Coastside Design Review Continuance 1120 Columbus Drive, El Granada APN 047-275-050; County File No. PLN 2017-00296

SUBJECT: Coastside Design Review Continuance

1120 Columbus Drive, El Granada

APN 047-275-050; County File No. PLN 2017-00296

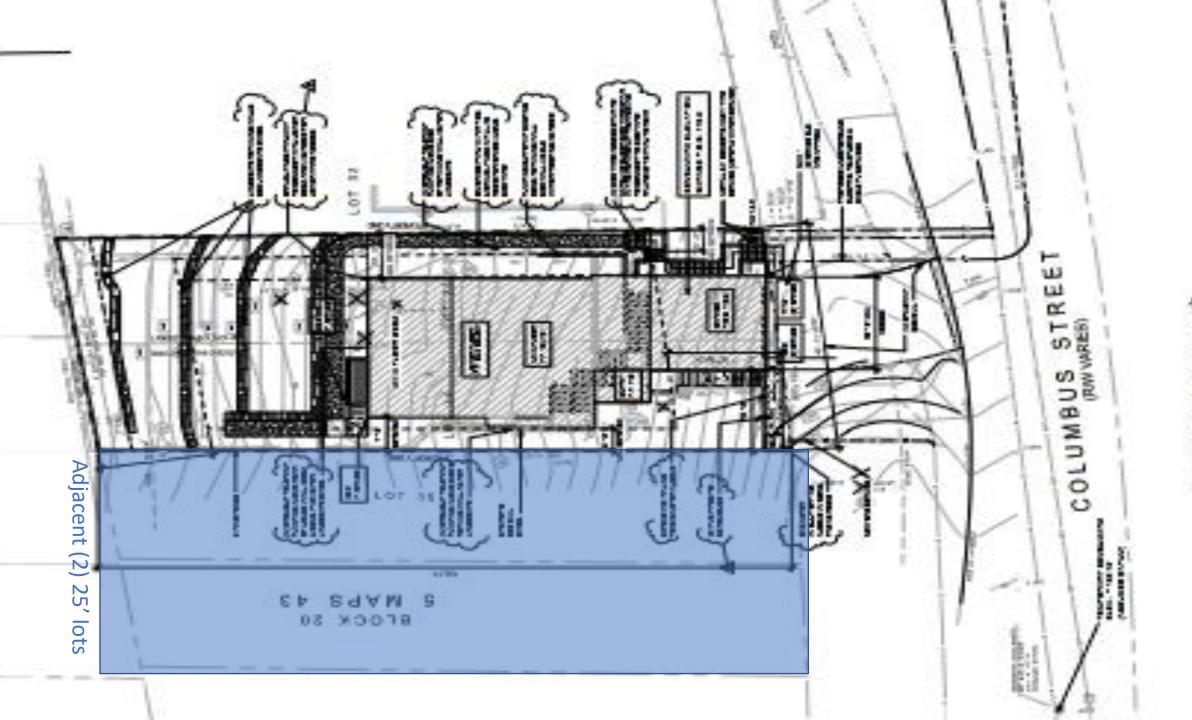
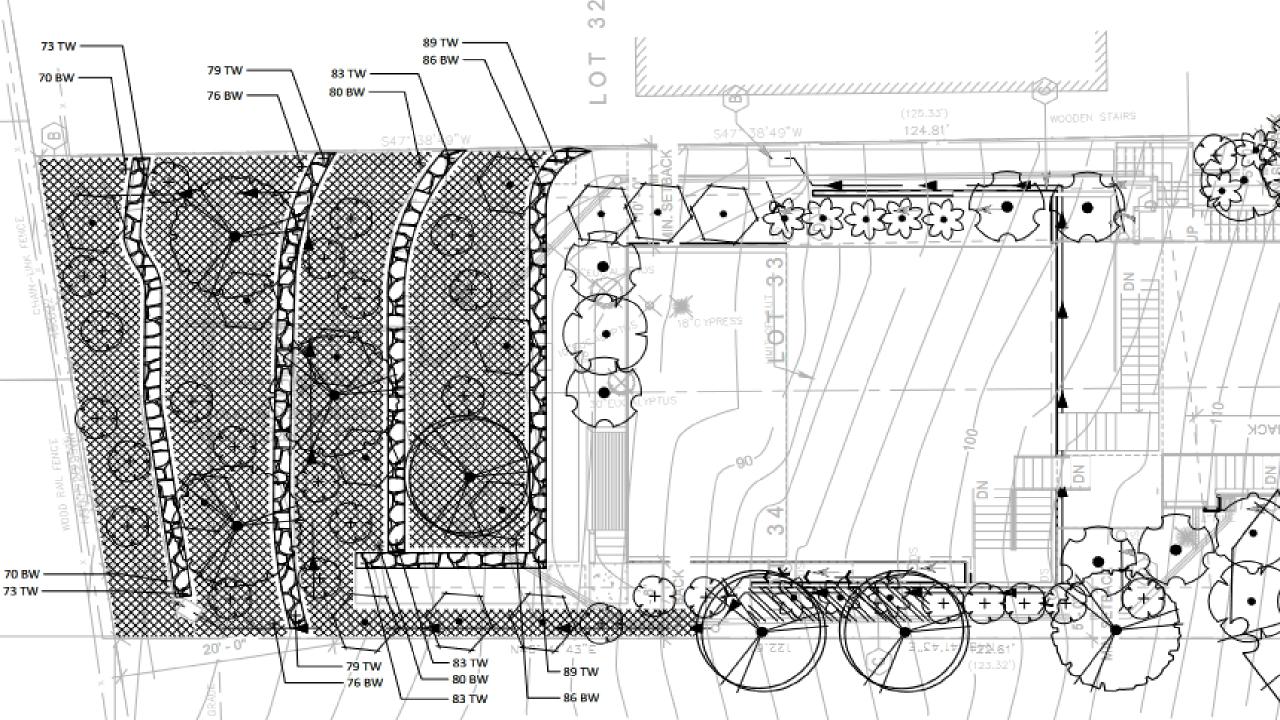
→ 19+ foot change in elevation between elevation at fence and building pad

→ Elevation change more than 6 feet between leveling off place at the bottom and the building pad

-- Current water runoff to the right-side bottom of lot (facing downhill from Columbus)

-- By adding fill and terracing will it require similar increases be made in elevations for adjacent property(-ies)

-- Will elevations on adjacent property(-ies) also have to be increased?
